# FINAL DESIGN PLAN

### May 5, 2009 Planning & Zoning Commission meeting

Report date	April 27, 2009
Project type	Multi-Family Residential
Legal description	Lot 9, Block 5, Wildridge Subdivision
Zoning	8 Unit Multi-Family
Address	1051 West Wildwood Road

**To:** Jeff Manley, AIA, Martin Manley Architects  
**From:** Carol Gill-Mulson, Deputy Chief, ERFPD  
**Date:** 3/25/2009  
**Cc:** Matt Gennett, Senior Planner, Town of Avon  
**Re:** Wildstar Residences, 1051 Wildwood Rd., Avon, CO

Product Details for the Forte Lighting 1041-01, Desert Stone Finish  
 Globe type bulb shown in photo is not to be used.

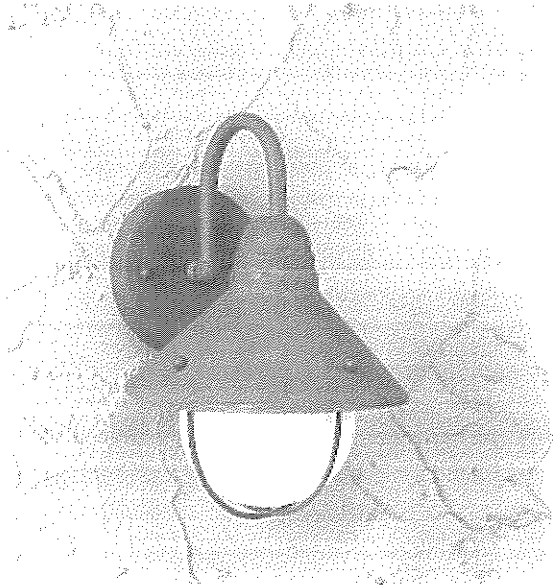
Bulb Type	Incandescent
Extension	8.5
Height	11.5
Material	Brass
Number of Bulbs	1
Suggested Room Fit	Outdoor
Theme	Contemporary / Modern
UL Approved	Wet Location
Watts	100W max (25W bulb to be installed)
Width	8
